May 17, 2023

RE: Comment on Proposed Recreation and Aesthetic Environmental Measures, Addendum to Final License Application, Rumford Falls Project (FERC No. 2333)

Jim Vogel, FERC Coordinator Bureau of Parks and Lands

(1) Cascades upstream of Portland Street bridge

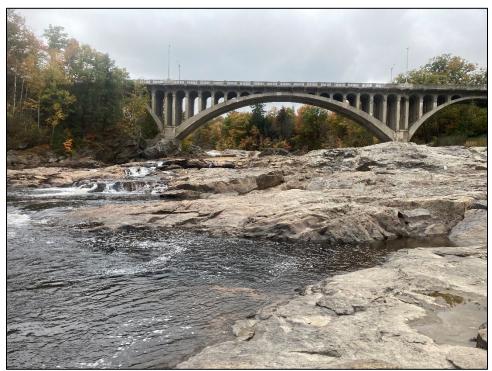
The Maine Department of Inland Fisheries and Wildlife (MDIFW), in their February 17, 2023 comments on the FLA, states "the current and proposed minimum flows for the Middle Dam bypass reach are extremely low and unacceptable" and recommends that additional flows (800, 1600, and 3200 cfs) be evaluated. MDIFW also states, based on their site observations and experience with evaluating aquatic habitats, that flows between 250-500 cfs appear to be appropriate. While the Aesthetic Flow Study focused solely on the Upper Dam bypass (Rumford Falls) and therefore did not evaluate flows at the Middle Dam bypass reach, the 250-500 cfs minimums flow proposed by MDIFW would undoubtedly provide aesthetic benefits at that location as compared to the current and proposed flows (95 cfs May-Oct, 54 cfs Nov-April), in addition to enhancing aquatic habitat. The attached photos, taken by MDIFW during the course of the flow study, depict flows in the bypass reach of 90 cfs (similar to the proposed May-Oct flows) and 190/265 cfs (similar to the lower end of MDIFW's proposed range); while not taken for the purposes of aesthetics evaluation, nor at identical locations for each flow, they provide visual corroboration of the aesthetic benefits of the higher flows.

studies. The Bureau will not comment on the biological basis of the proposed minimum flows, with the expectation that FERC and RFH will continue to engage with MDIFW on their concerns. However, on the basis of the potential for an enhanced fishery and the aesthetic benefits discussed above, the Bureau supports MDIFW's recommendation for increased minimum flows for the Middle Dam bypass reach and, if necessary, additional analysis to arrive at the most balanced minimum flow requirement for the new license.
